PERMIT

SEWAGE DISPOSAL SYSTEM
HOWARD COUNTY HEALTH DEPARTMENT
BUREAU OF ENVIRONMENTAL HEALTH
410-313-2640

SUBDIVISION Village of Three Keys LOT NUMBER 4 ADDRESS 15190 Bushy Park Road

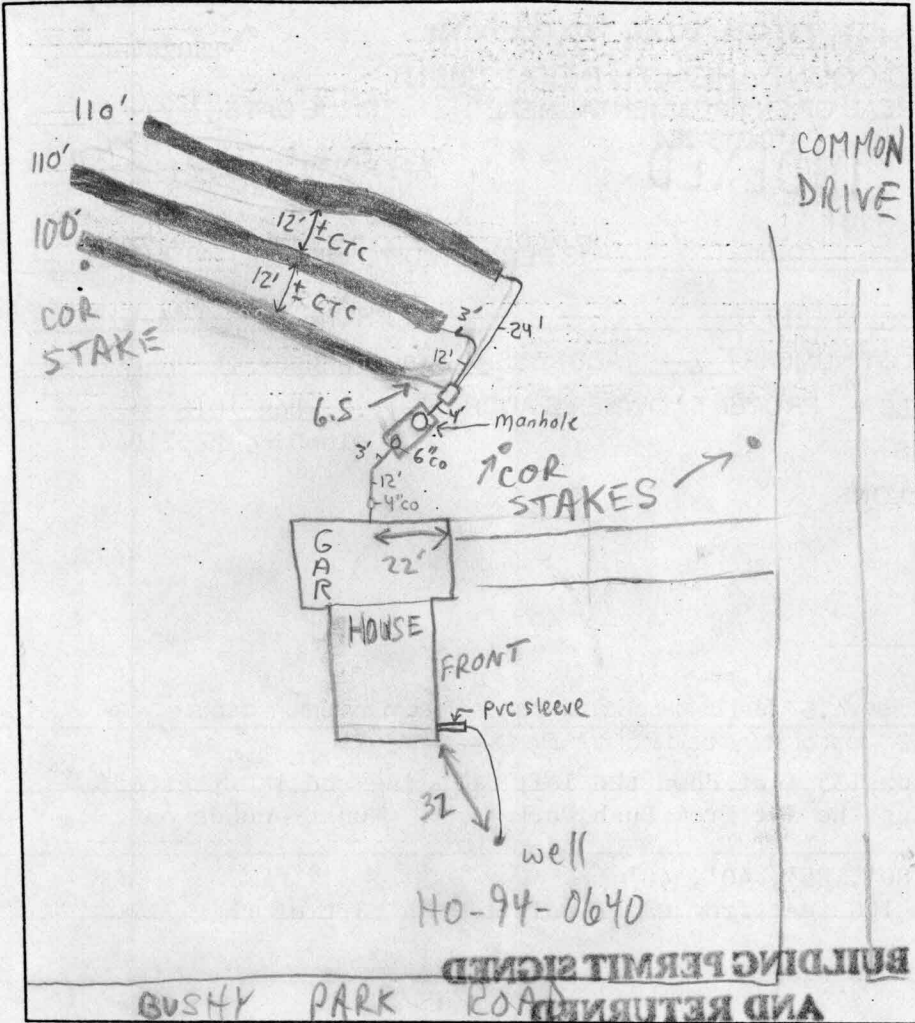
PRE-CONSTRUCTION INSPECTION: 3/23/01 OK FOR 3 TRENCHES, 100, 110, 110 (MR)

INSPECTION COMMENTS: 3/23/01 OK TO COVER TRENCH (1), CONTINUE (MR)

3/26/01-OK TO COVER ALL WORK - (SRW)
